**Information Bulletin No. 019.7.58.005 I**

**Inspection of the tow release**

**control system**

**Type:** LAK-19

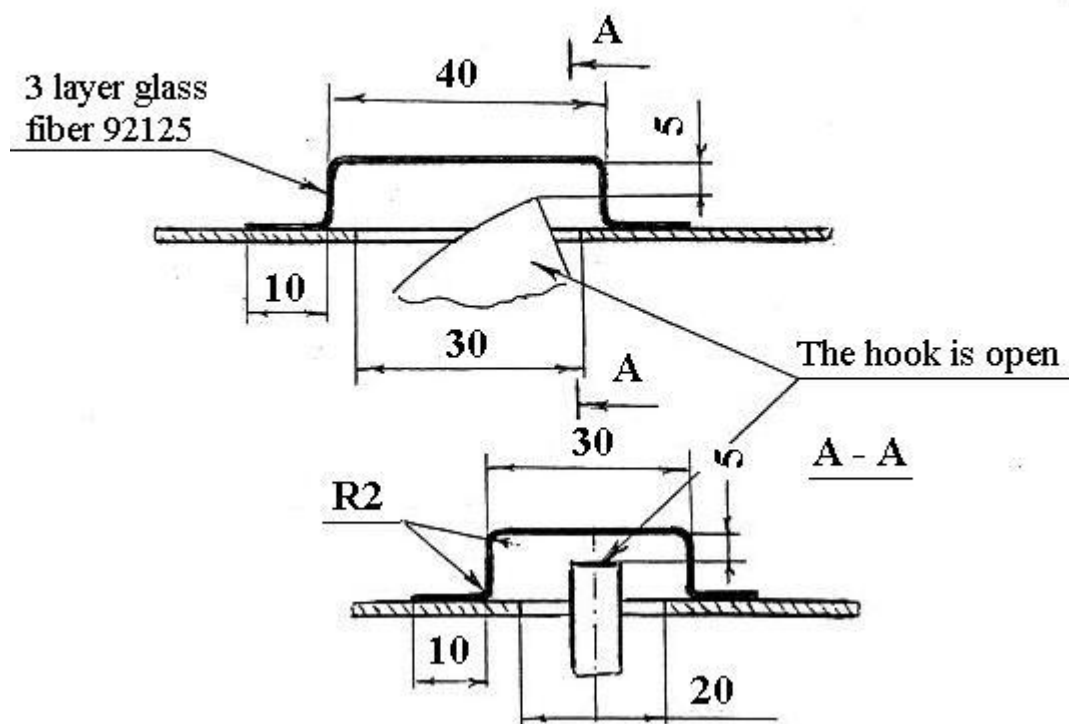
**5. Actions:** For inspection of the tow release control system you must according "Maintenance manual for the LAL-19 sailplane" page 2/32 Fig. 2-10 Towing hook control, check motion of the tow release handle. Motion of the handle must be 55 mm.

If motion of the handle is less 55 mm you must removed the cover from towing hook, arranged in central part of fuselage at the main frame and chech motion of the tow release handle. If motion of the handle is 55 mm it signify – the release mechanism was rubbing against the top of cover. For correction it is necessary:

- a) Made a hole according photo No 1.
- b) After cutting hole it is necessary to mount cover and inspect tow release control system (see photo No 2, 3) according fig. 2-10 towing hook control.

After inspection you must hole close with glueing 3 layer glass fiber 92125 cover according Sketch No 1 or place an order for new cover.
